SITE PLAN REVIEW

LOT NO 11 REGISTERED PLAN

CLIENT	HIGHCASTLE HOMES
PROJECT/LOCATION	RIVERWALK, PHASE 2 BRAMPTON, ON
DRAWING	SITE PLAN

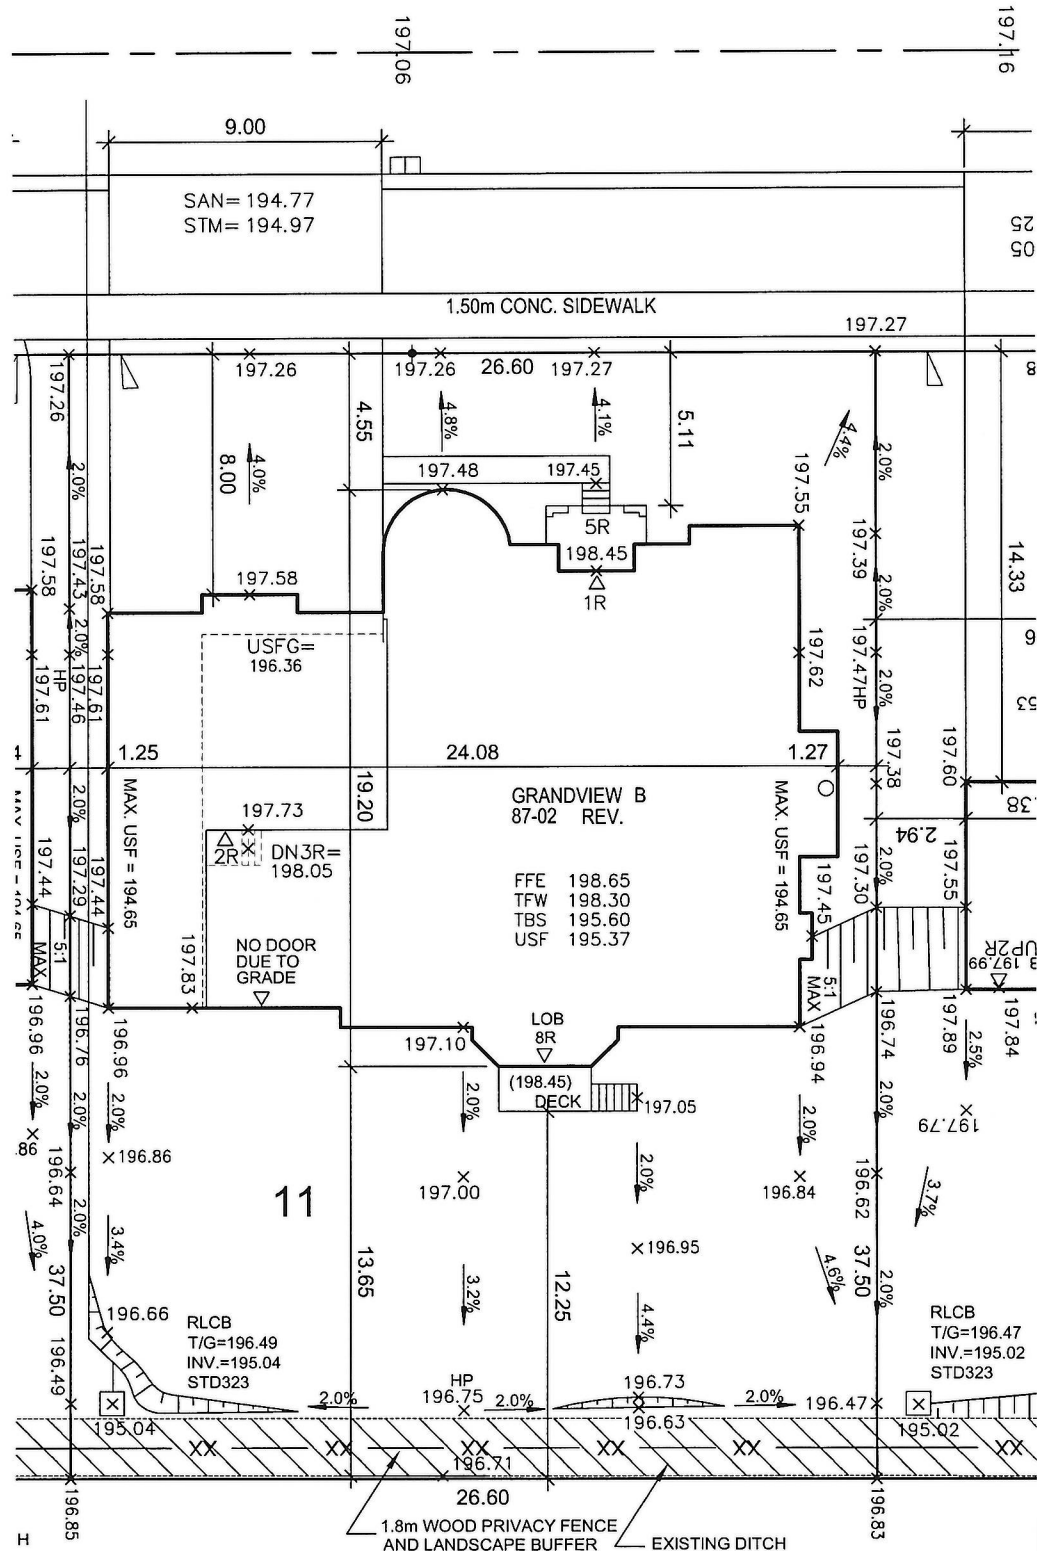
THE PROPOSED LOT GRADING AND DRAINAGE IS APPROVED AS BEING IN CONFORMITY WITH THE OVERALL APPROVED GRADING PLANS FOR THE SUBDIVISION.
